Accessibility Survey

Public Works Utility Yard

9252 Stewart and Gray Road
Downey, CA 90240

Date of Inspection
1/17/2017

Offices Next To Break Room

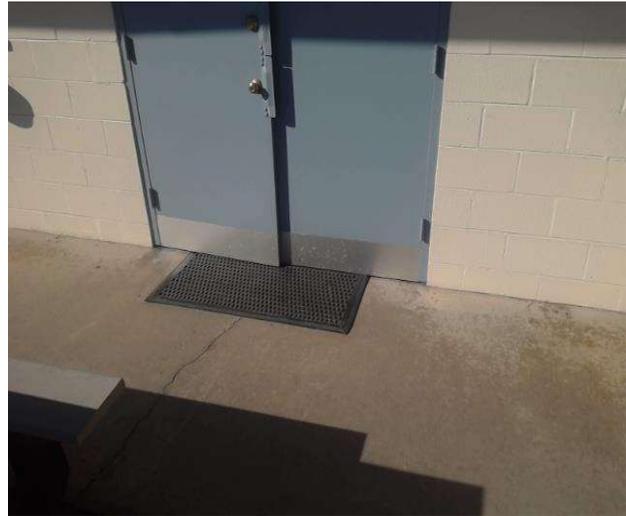
An unstable floor mat is provided at the door landing.

On-Site Finding Not Compliant

Provide a compliant floor mat for the door.

Main Entrance

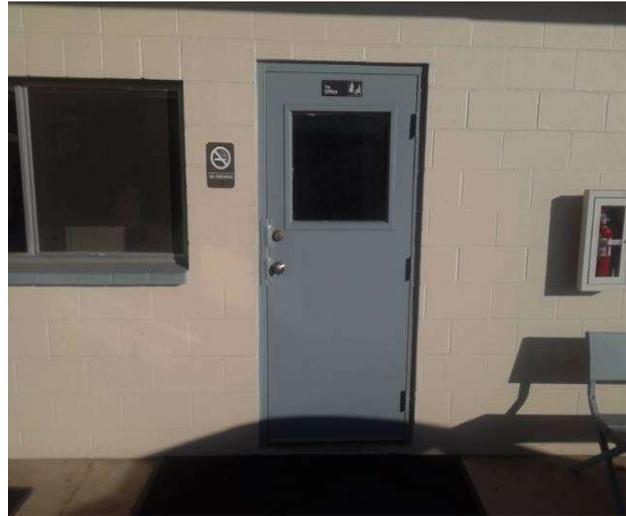
There is no room signage.

On-Site Finding None Found

Install accessible room signage.

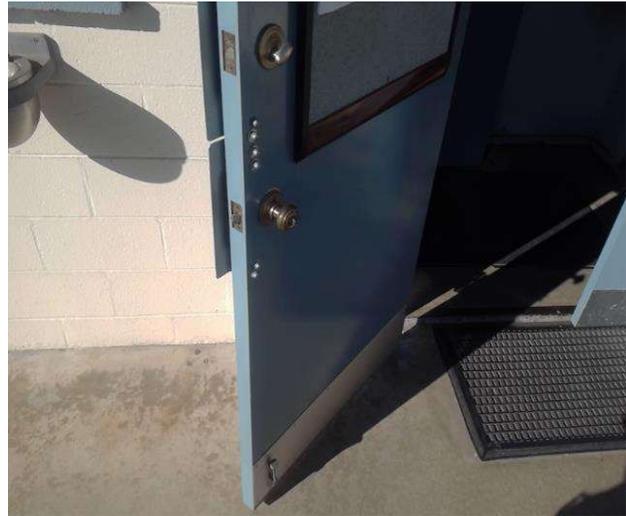
The door opening hardware is not accessible.

On-Site Finding Not Accessible

Provide accessible hardware on the door.

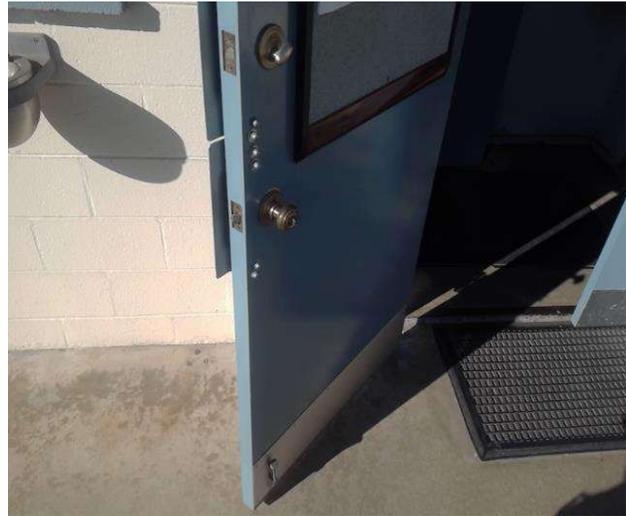
Door hardware is not mounted at the correct height.

On-Site Finding 49.50 inches

Mount the door hardware at the recommended height.

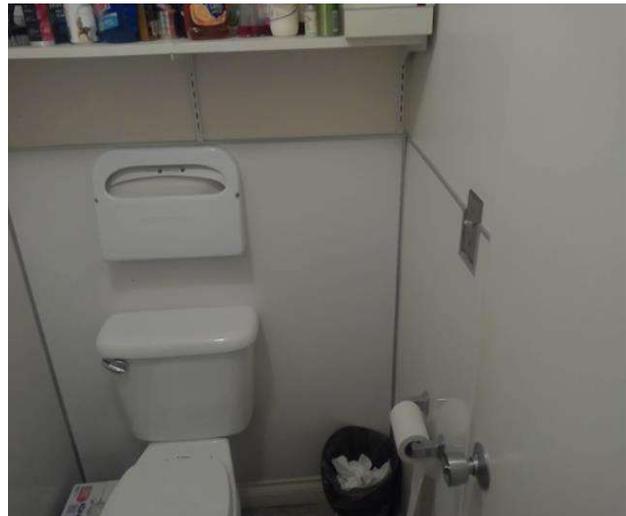
There are no grab bars.

On-Site Finding None Found

Install the required grab bars in the toilet compartment.

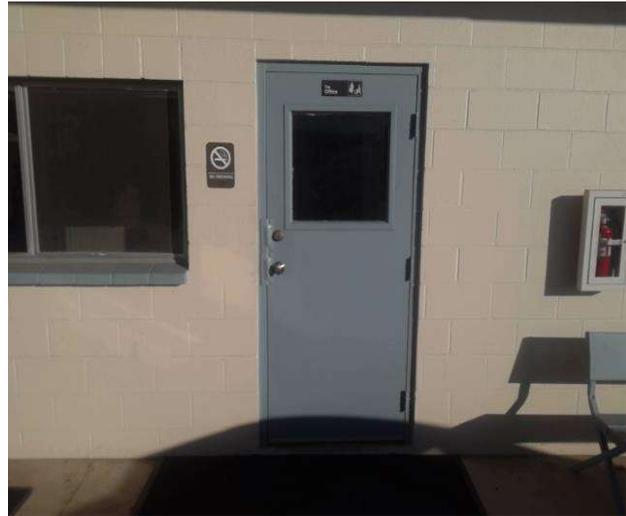
The door closing device limits the required headroom clearance.

On-Site Finding 77.50 inches

Replace the door closing device with a device that fits above the door casing and does not protrude into the primary path of travel.

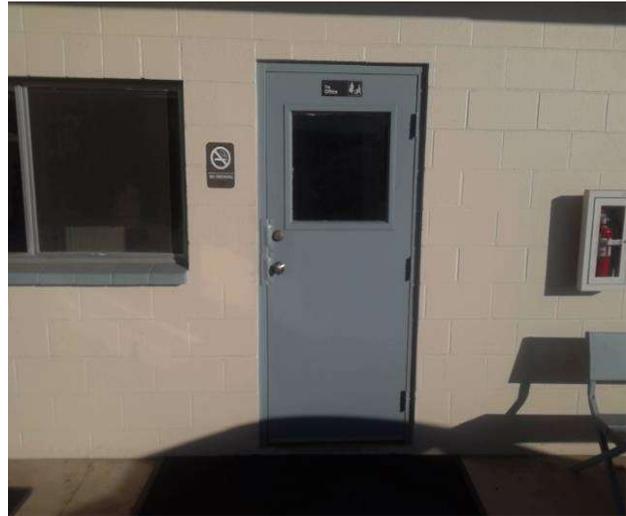
The clear opening width of the door is less than required.

On-Site Finding 31.25 inches

Widen the door opening and install a door that provides at least the minimum clear width with the door open 90 degrees.

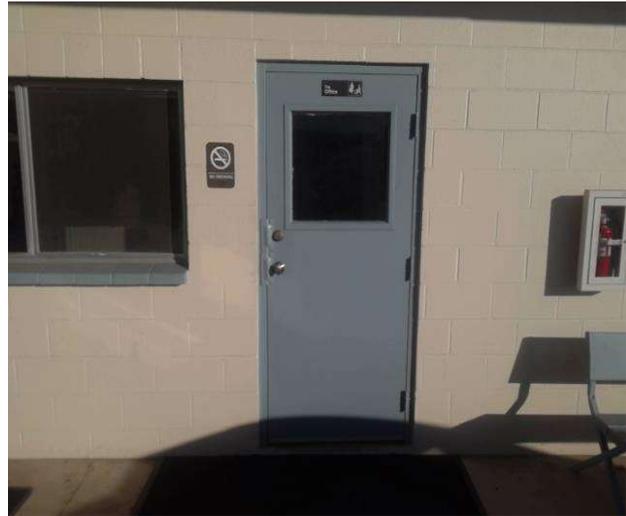
The vertical clearance height of the door is less than required.

On-Site Finding 78.87 inches

Extend the height of the doorway to provide the required clearance height.

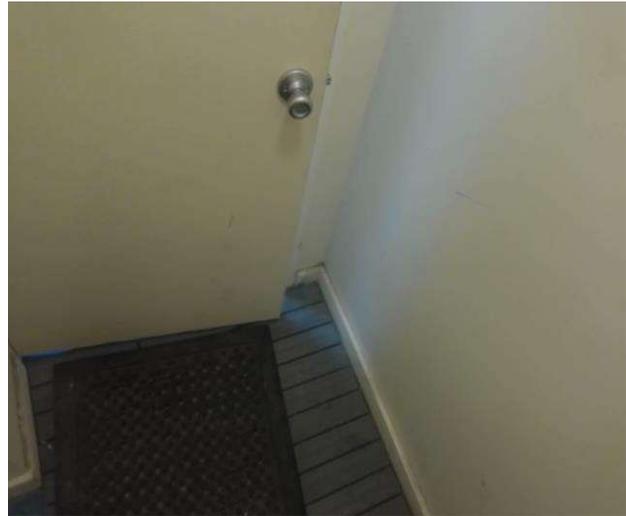
There is not enough clear floor space provided at the pull side of the door.

On-Site Finding 45.62 inches

Provide the recommended clear floor space on the pull side of the door.

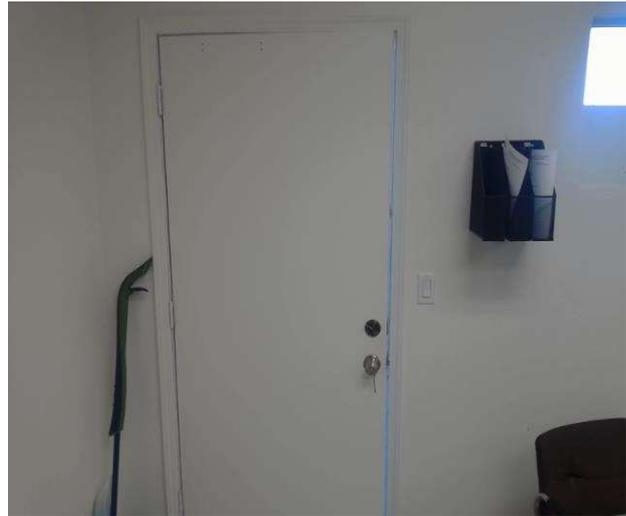
The vertical clearance height of the door is less than required.

On-Site Finding 79.50 inches

Extend the height of the doorway to provide the required clearance height.
